7 July 2017

RE: Submission - North West Priority Growth Area Land Use and Infrastructure Implementation Plan

GLN has been engaged by the owners of Lot 211, DP 830505, 36 Garfield Road, Riverstone, comprising the majority of the Riverstone West Precinct, to review the North West Priority Growth Area – Implementation Plan (the **Plan**) and related exhibition documents including an Explanation of Intended Effect (**EIE**) on proposed amendments to *State Environmental Planning Policy (Sydney Region Growth Centres) 2006 (Growth Centres SEPP)*.

Figure 3 Riverstone Town Centre bypass option

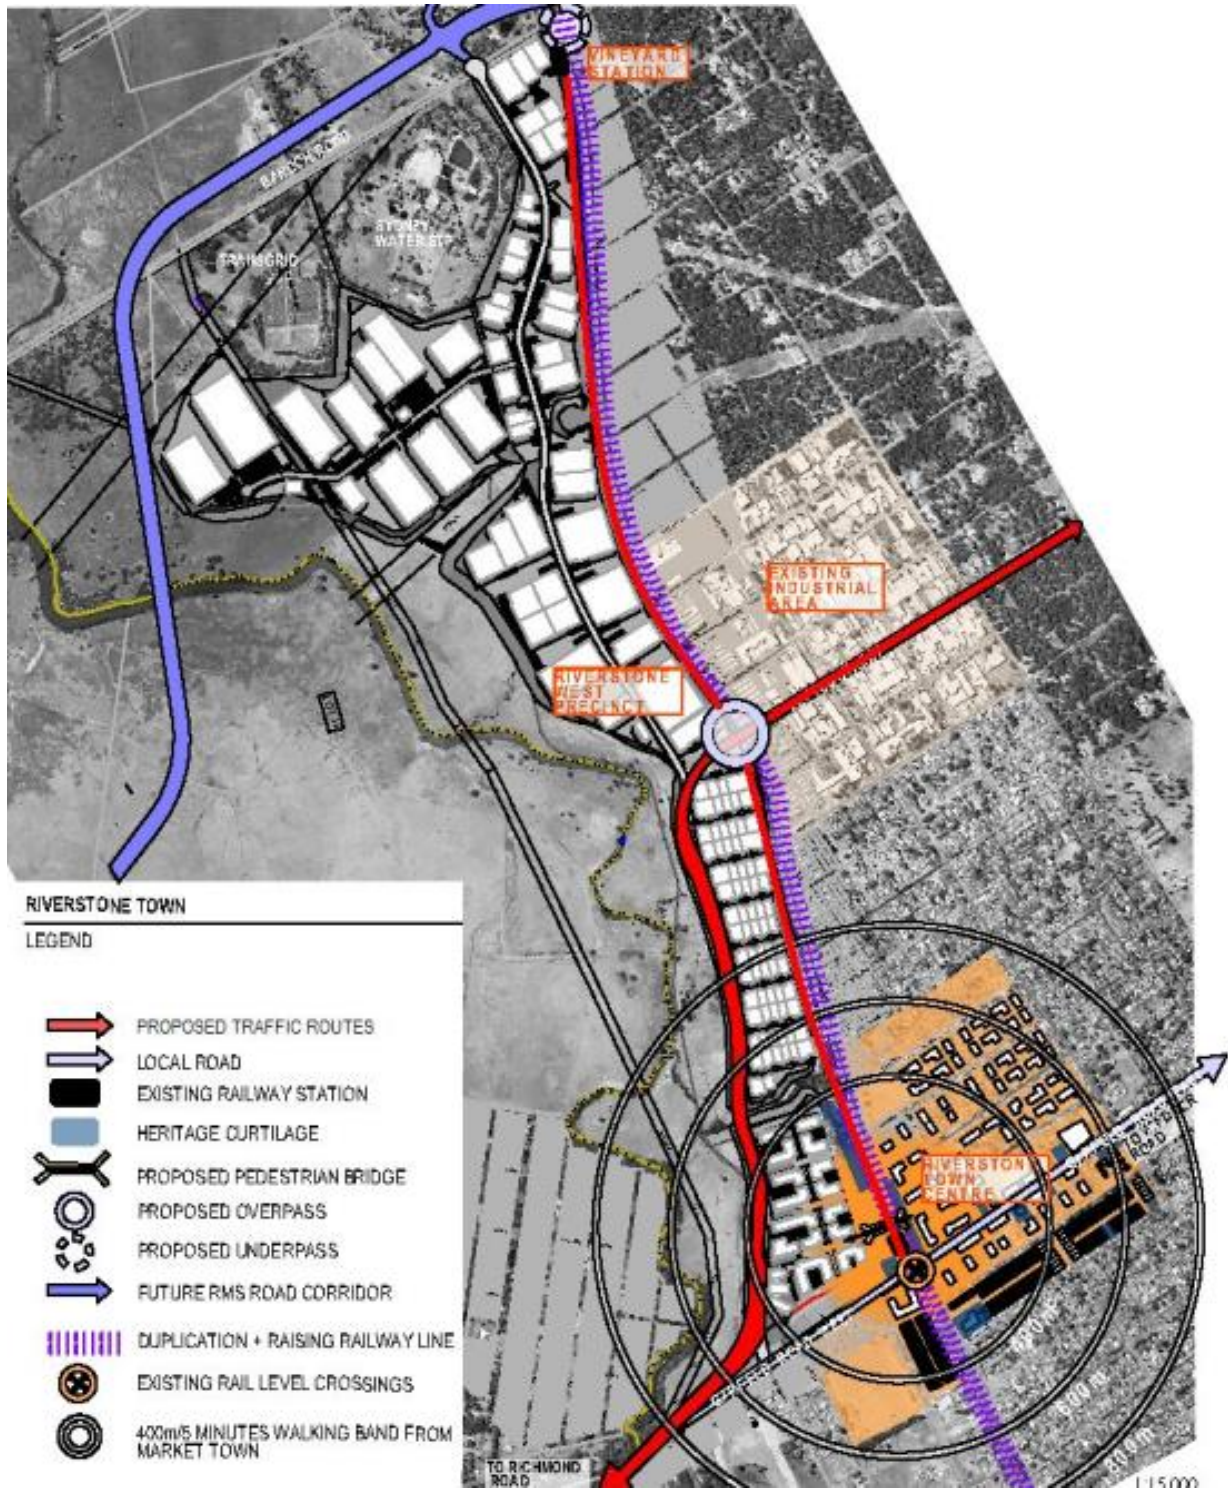
An alternative to the Garfield Road extension along the existing road alignment would be to deliver this grade separated crossing further north which bypasses the town centre – refer to **Figure 3**. The benefits of this bypass option include:

The bypass could be encapsulated within the Plan by including it within Figure 20 as an alternative option. Its recognition in the Plan would then facilitate further investigation into this bypass option, and provides more flexibility in resolving potential issues that will likely be experienced with the current alignment shown within the Plan.

Figure 5 Extract of Growth Centres SEPP – Development Control Map

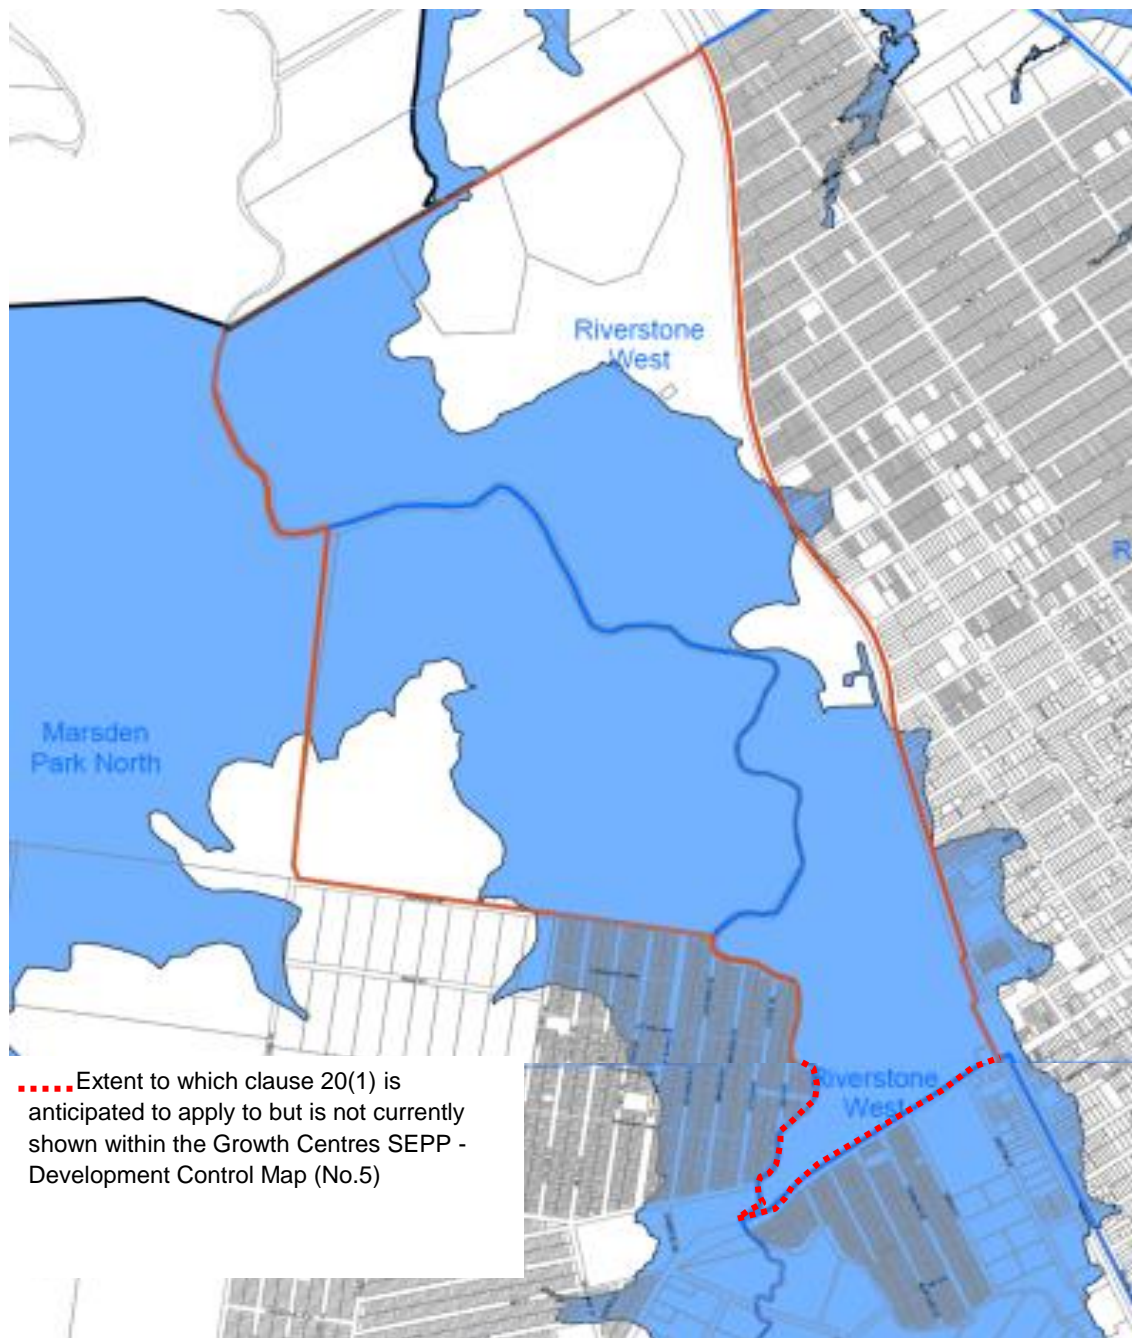
The red line outlining the extent to which clause 20(1) applies is missing from Development Control Map - Map No.5 of the Growth Centres SEPP. This relates to the southern portion of the subject site and is considered to be a mapping error that could be updated as part of this Planning Proposal to clearly define this (shown as a dotted red line in **Figure 5**).
